SAFETY EVALUATION BY THE OFFICE OF NUCLEAR REACTOR REGULATION

SUPPORTING DRESDEN UNITS 2 AND 3 COMPLIANCE WITH GDC-17

DRESDEN NUCLEAR POWER STATION, UNIT NOS. 2 AND 3

DOCKET NOS. 50-237/249

FIGURE 1. 345kV AND 138kV DISTRIBUTION

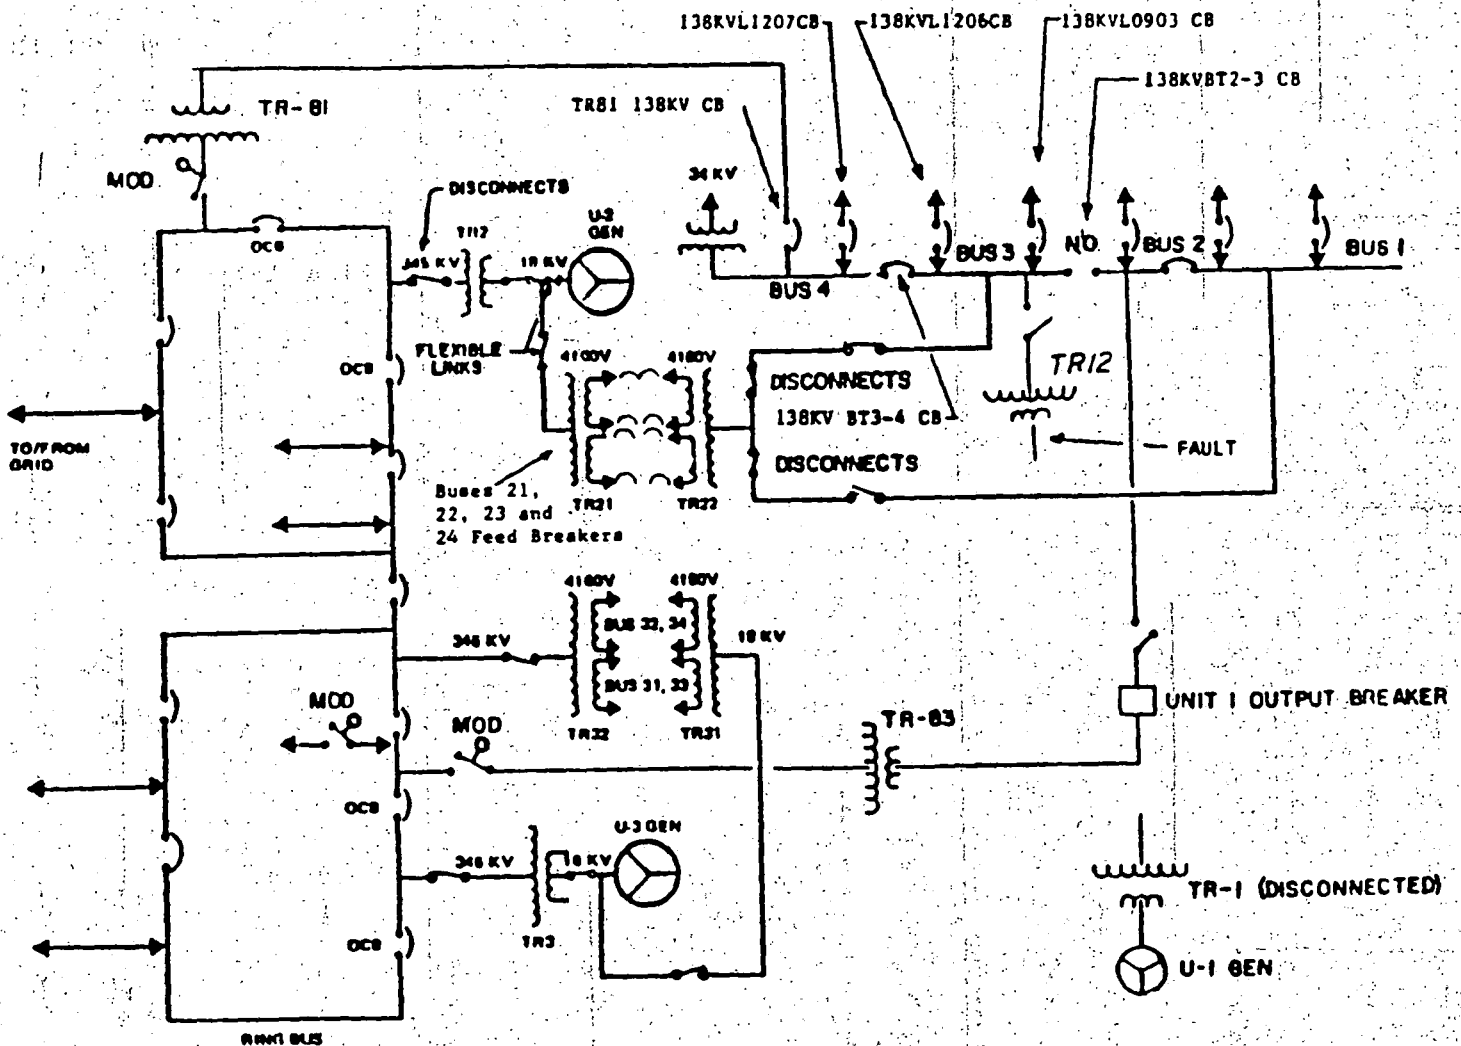
Figure 1 illustrates the configuration of offsite power at the switchyard. The electrical system for the Dresden station is shown in Figure 2. During normal power operation of each unit, one division of the safety-related electrical distribution system is energized from the plant's main generator via the unit auxiliary transformer (e.g., TR-22, for Unit 2). The design includes a feature to fast transfer the loads on the reserve auxiliary transformer to the unit auxiliary transformer in the event of a power loss.

The event caused the staff to question the acceptability of plant operations with Unit 2 reserve auxiliary transformer TR-22 aligned to 138KV bus section 3 in addition to Unit 1 transformer TR-12 aligned to the same bus section. At issue is the increased vulnerability to loss of the GDC-17 immediate-access offsite power circuit for Unit 2 (TR-22) caused by electrical faults on Unit 1 equipment (TR-12) due to not feeding these transformers from separate bus sections of the 138 KV switchyard. The plant licensing basis (i.e., Final Safety Analysis Report (FSAR)) shows the Unit 1 transformer TR-12 powered from bus section 3 and the Unit 2 transformer TR-22 powered from either bus section 1 or 3, with the connection to section 1 being "normally closed". The staff's review of the August 1985 event revealed that the plant is operated with TR-22 energized preferentially from bus section 3, which is the same source used for TR-12. The licensee responded to staff concerns by letters dated August 22, December 13, and December 31, 1985. The licensee has described its basis for concluding that the offsite power alignment that was and is currently in use provides the best reliability and flexibility.

FIGURE ..2 AUXILIARY ELECTRICAL SYSTEM - 4160 VOLT AND 480 VOLT

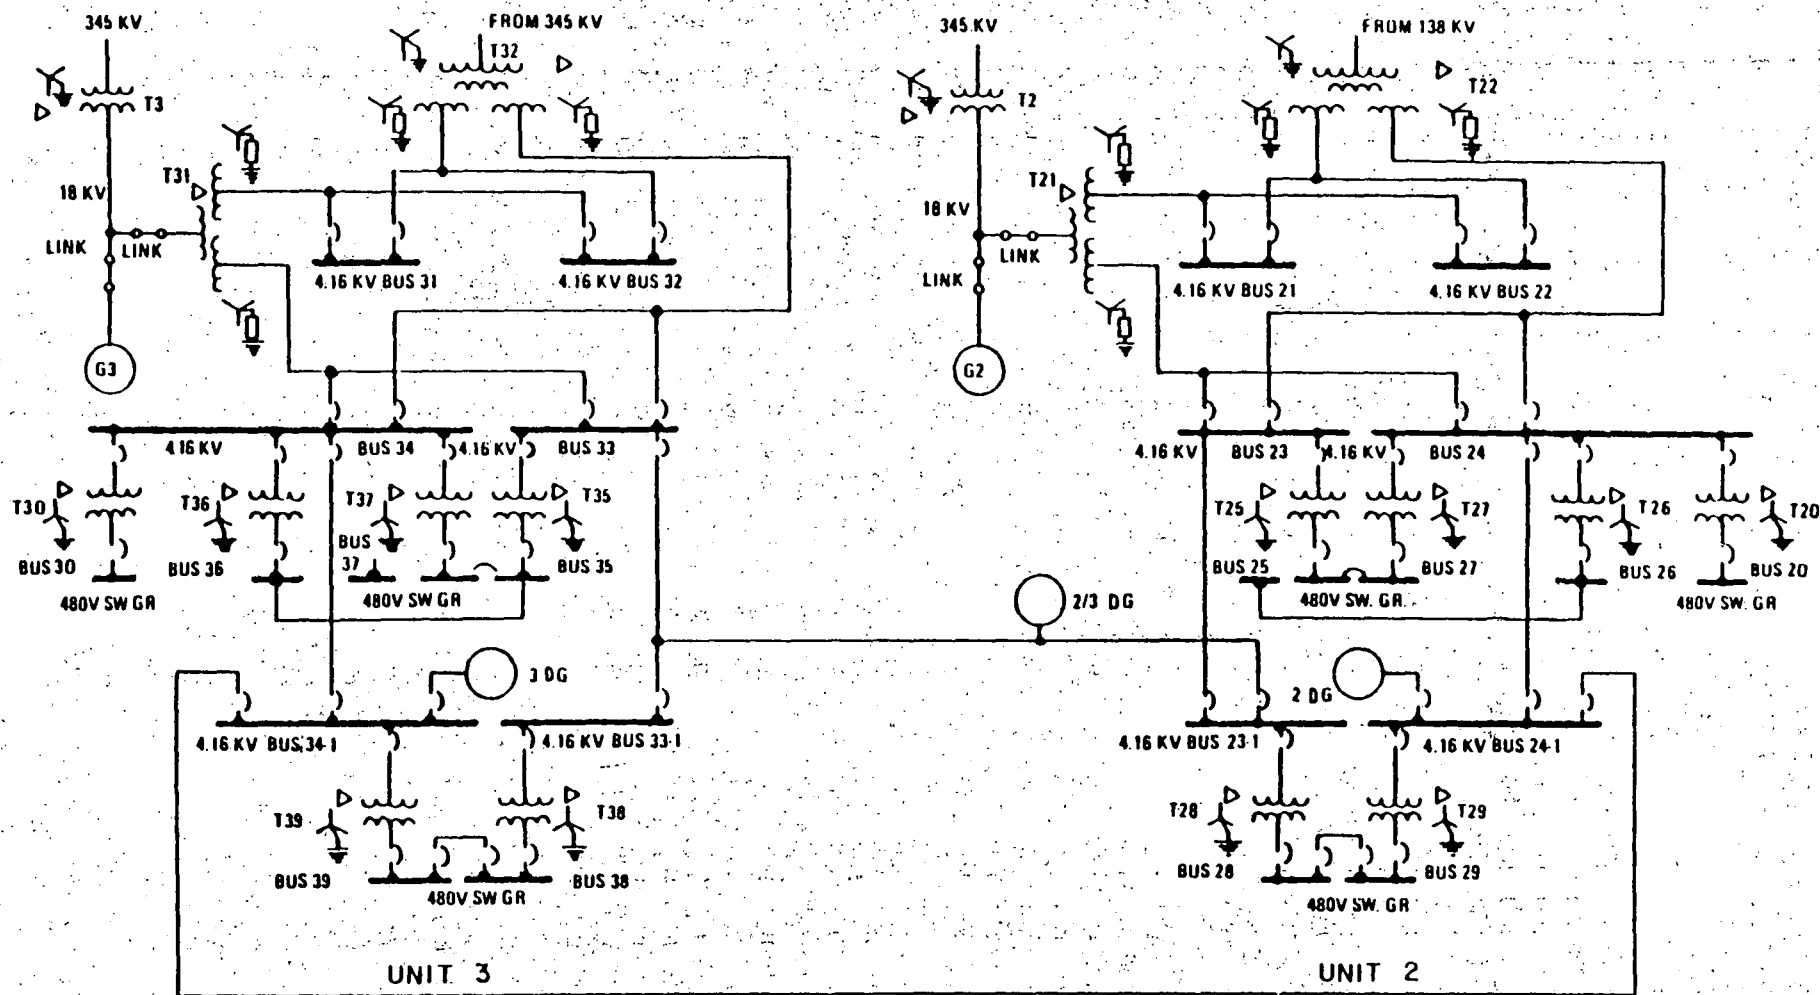
Licensee investigation of the 4KV breaker control circuitry determined that the feeder breakers for 4KV buses 22 and 24 were not designed, as believed, to automatically transfer power feed from the normal supply, reserve auxiliary transformer TR-21. Licensee review identified a design error in the closing control circuits of certain bus 22 and 24 feed breakers which prevented the automatic power transfer from TR-22 to TR-21. The design error resulted from a previous modification. Specifically, the modification was intended to cause a fast transfer of certain buses from the TR-22 as the source of power to TR-21; however, the design of the transfer logic assumed (and required) that any loss of TR-22 would involve a fault which would lead to the electrical lockout of the transformer. During the August 1985 event the transformer output ceased simply because of loss of incoming power, without an actuation of the lockout relay for the transformer. Therefore, the transfer did not function. This transfer feature is necessary to satisfy the portion of GDC-17 which requires that the loss of an offsite circuit not cause the loss of the plant main generator, which could happen if power is lost to certain equipment such as feedwater pumps which in turn cause a plant trip.

The licensee's GDC-17 analysis states that the Unit 2 second access source of offsite power required by GDC-17 consists of a 4KV cross-tie between Unit 2 and Unit 3 via bus-tie 24-1/34-1. The second source of power is normally supplied from the Unit 3 345KV switchyard. The second source of offsite power can be activated from the main control room via two breaker control switches and was available during the August 16, 1985 event. The analysis states that the load carrying capability of the bus-tie has been evaluated and determined to be adequate to support the necessary emergency loads. The licensee load analysis includes only one division of emergency loads. This design satisfies the interpretation of GDC-17 that was used when Dresden 2 and 3 were licensed.

The design error has been corrected and the transfer scheme has been tested satisfactorily. NRC Region III has reviewed the modification and observed post-modification testing of the automatic transfer function from TR-22 to TR-21. The results of the Region III review were published in a letter to the licensee dated September 27, 1985.

Based on staff and regional review of licensee corrective actions relative to the automatic transfer of power feeds from transformer TR-22 to transformer TR-21, design is consistent with the guidelines of Regulatory Guide 1.32 and the commitments made in the updated FSAR.
